**Ascension Catholic Elementary School Renovation
PROJECT NO. 24137
HOSSACK ARCHITECTURE**

ADDENDUM NO. 3

April 01, 2025

SECOND FLOOR RCP

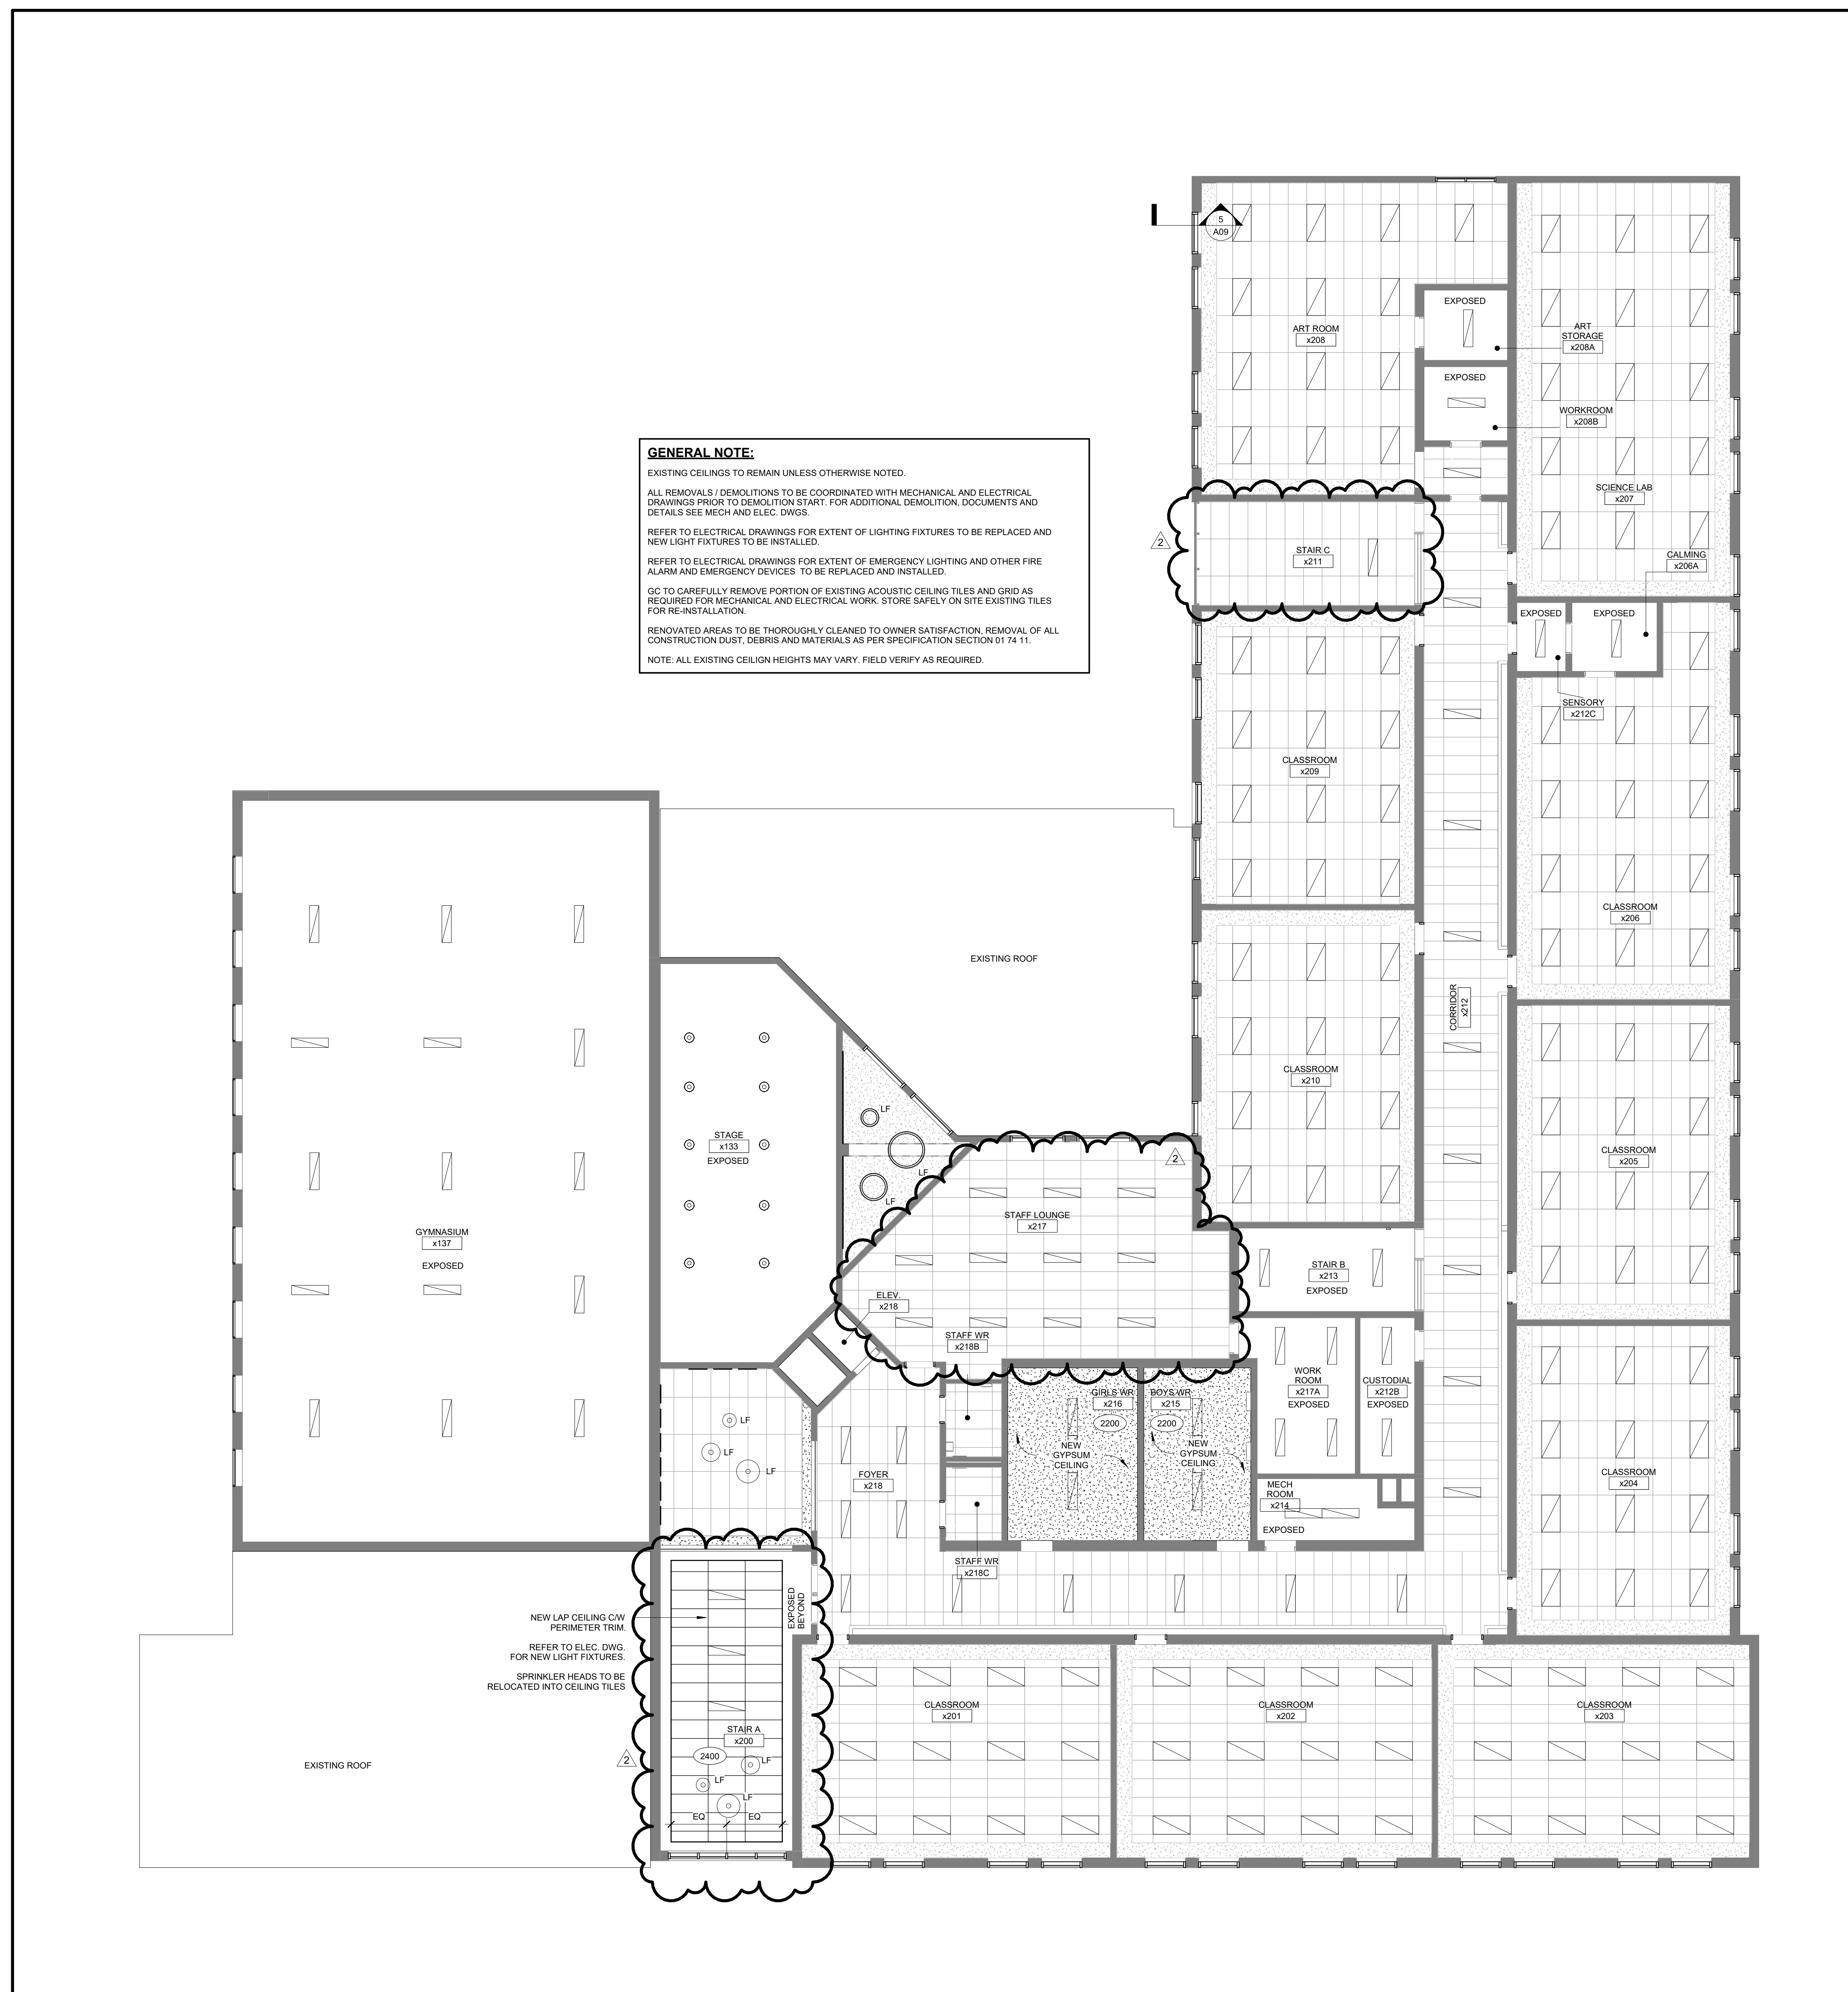
- .1 REPLACE with enclosed drawing in its entirety. (Drawing updated to included existing LAP ceilings in Staff Lounge x217 and in Stair C x211) (New lighting fixtures added in Stair A x200, refer to electrical addendum no.3).

NEW LAP CEILING CAV PERIMETER TRIM REFER TO ELEC. DWG. FOR NEW LIGHT FIXTURES.
 SPRINKLER HEADS TO BE RELOCATED INTO CEILING TILES

DWG TITLE:
PROPOSED LED LIGHTING RETROFIT GROUND FLOOR PLAN

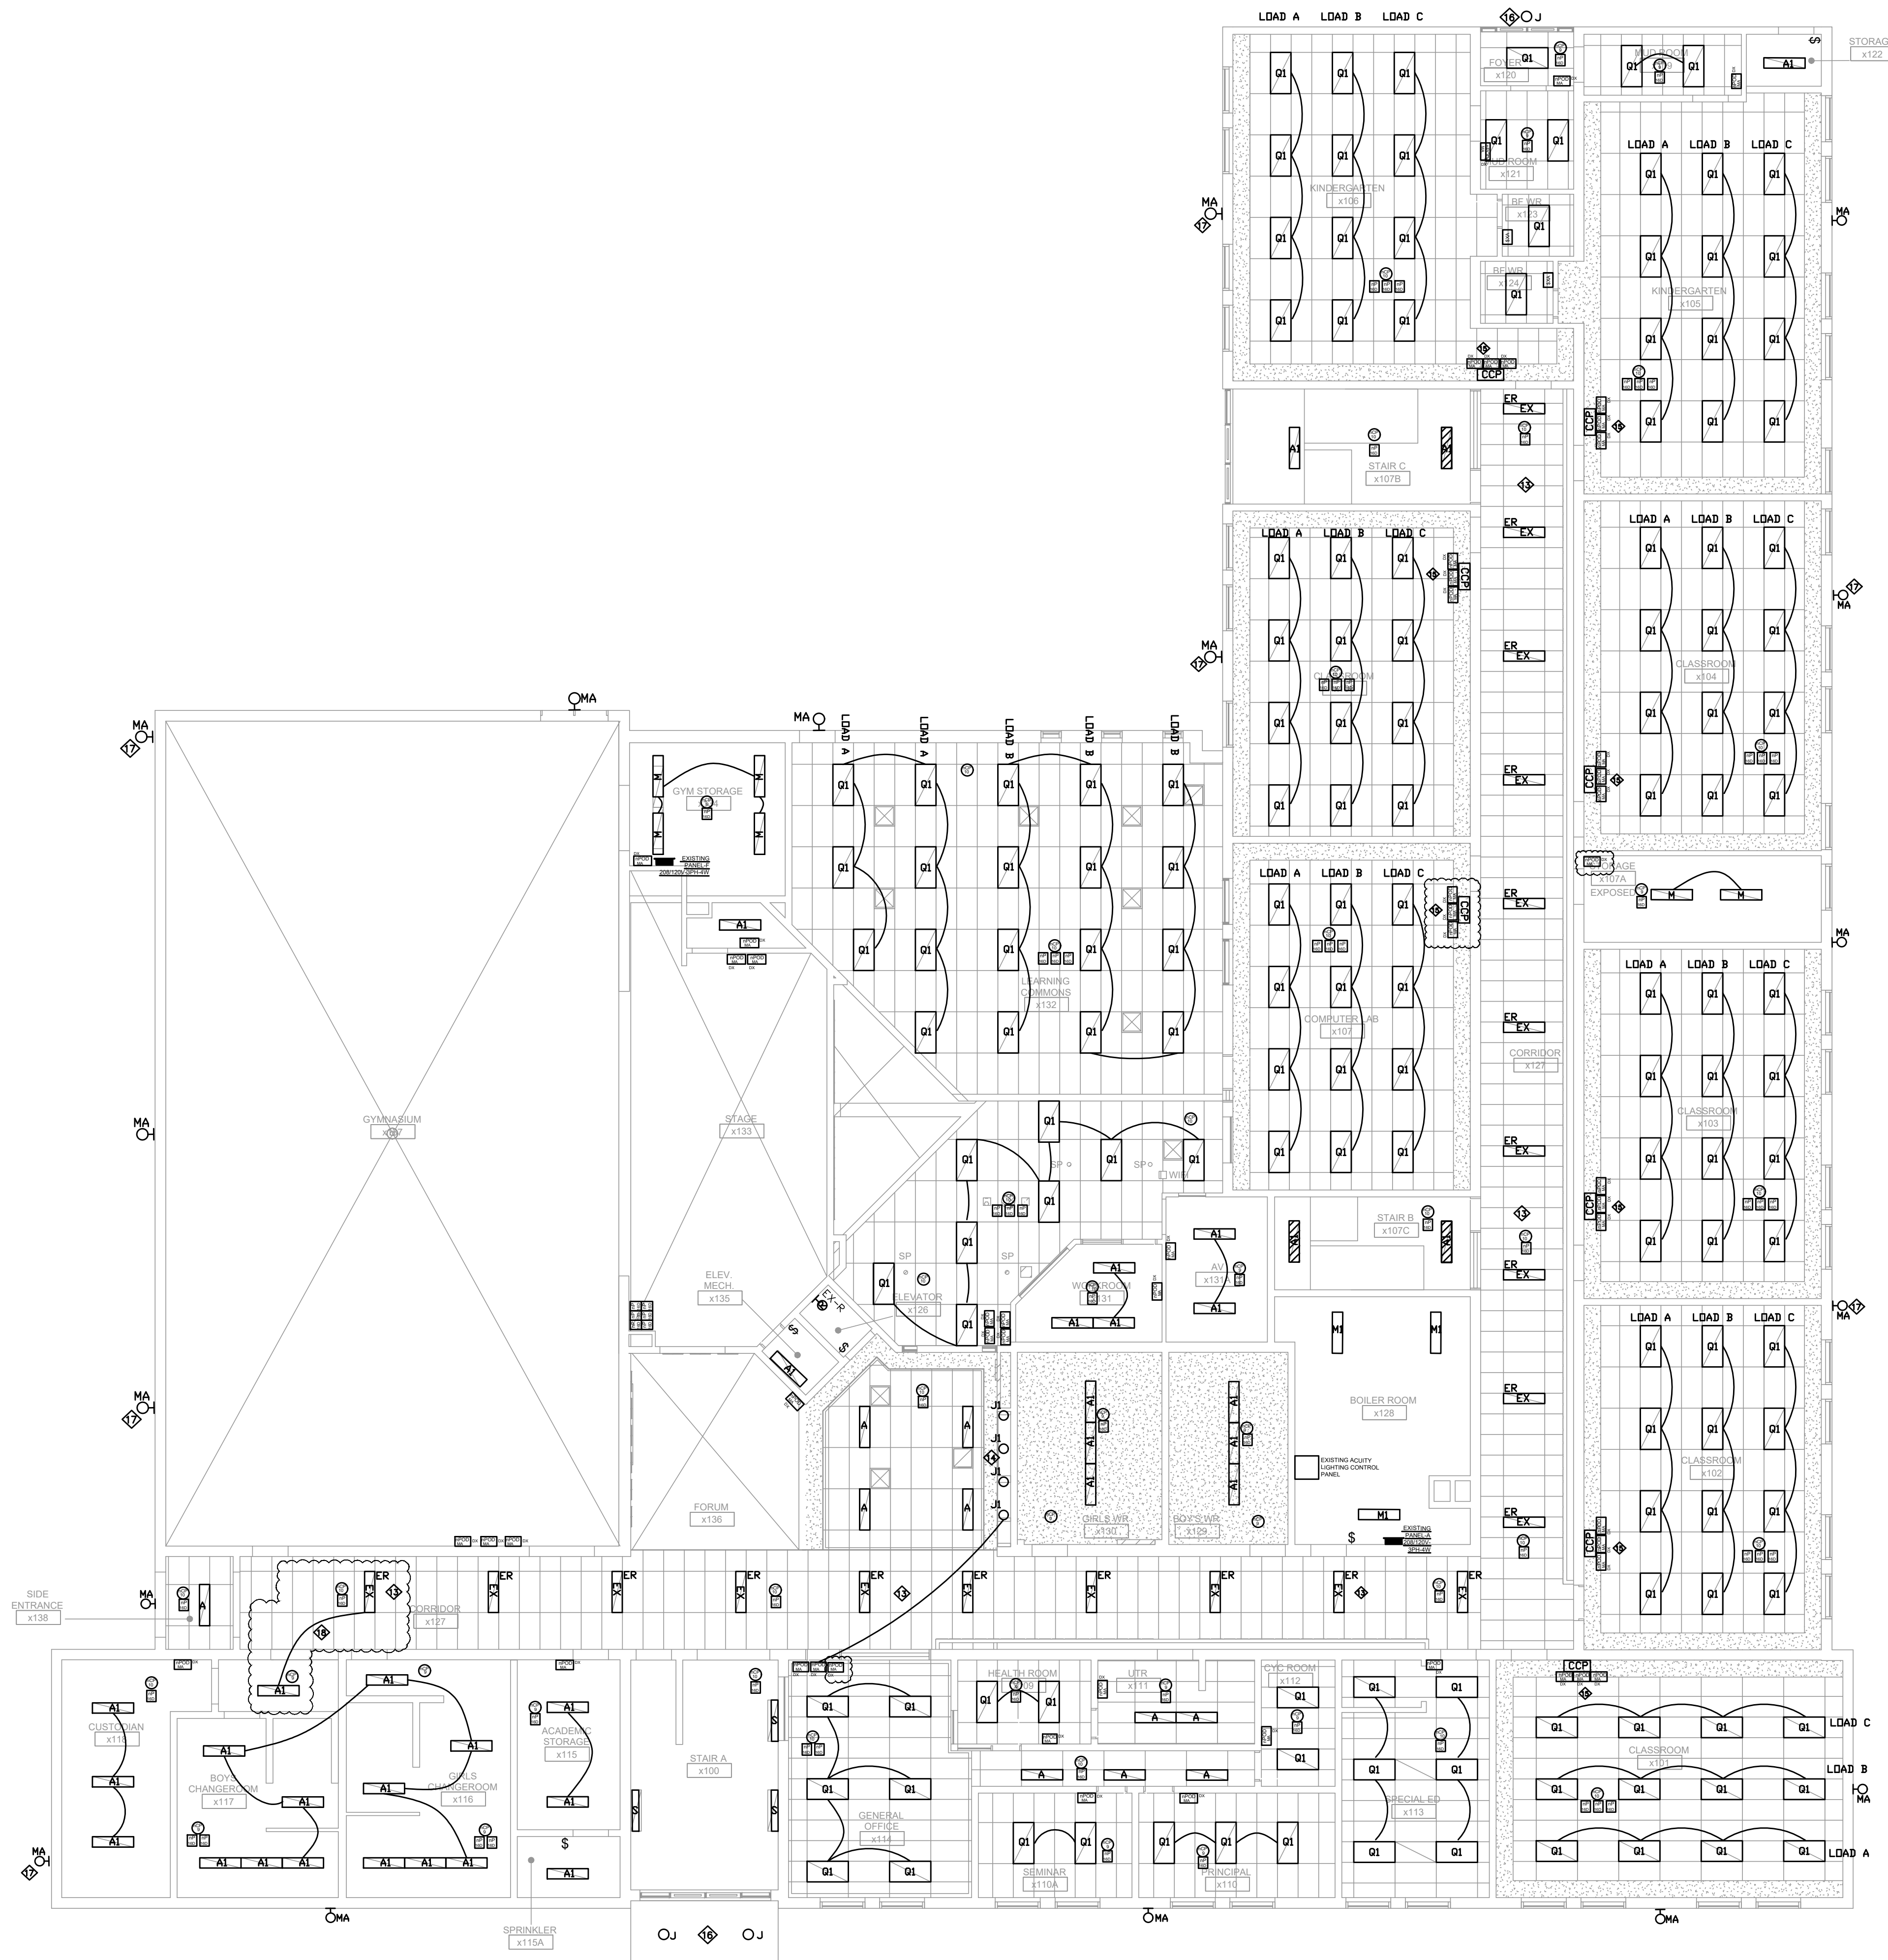
1. Replace/add the drawings with as under:
 1. Find attached revised electrical drawing E1.0-A-2 with changes shown as clouded.
 2. Find attached revised electrical drawing E3.0-A-2 with changes shown as clouded.
 3. Find attached revised electrical drawing E3.1-A-2 with changes shown as clouded.
